PARTS BULLETIN

Model: **60-100GS**Market: **Industrial**Subject: **Field Exciter Assembly Correction**

Figure 1. Alternator Components

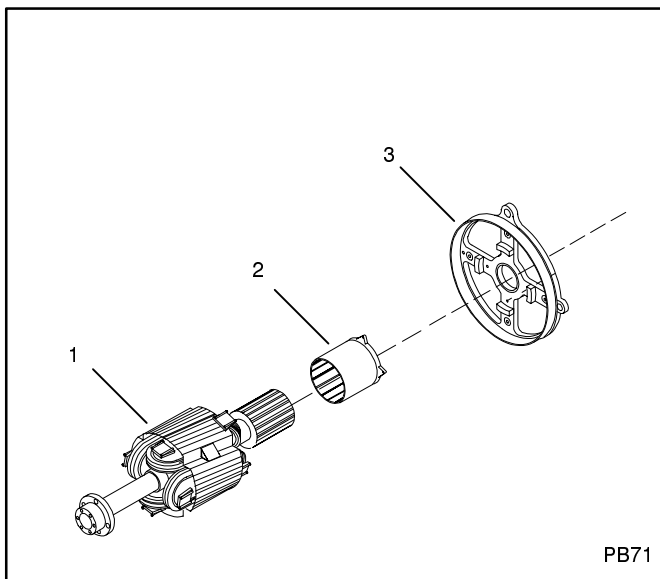
Parts Catalog MP-5614 lists the wrong field exciter assembly part number for some generator set specifications. See Figure 1 for a picture of the field exciter assembly. Choose the correct part number from the chart below. Please make a note of the correction in Parts Catalog MP-5614 4/96, 50-100GS, page 33, item 29.

Generator Set Specification	Field Exciter Part Number
60GS	
193040	276657
193043	276657
70GS	
193045	276657
193046	276657
193047	276657
193048	276657
193049	276657
193050	276657
80GS	
193051	276657
193052	276657
193053	276657
193054	276657
193055	276657
193056	276657
100GS	
193057	276657
193058	276657
193059	276657
193060	276657
193061	276657
193062	276657
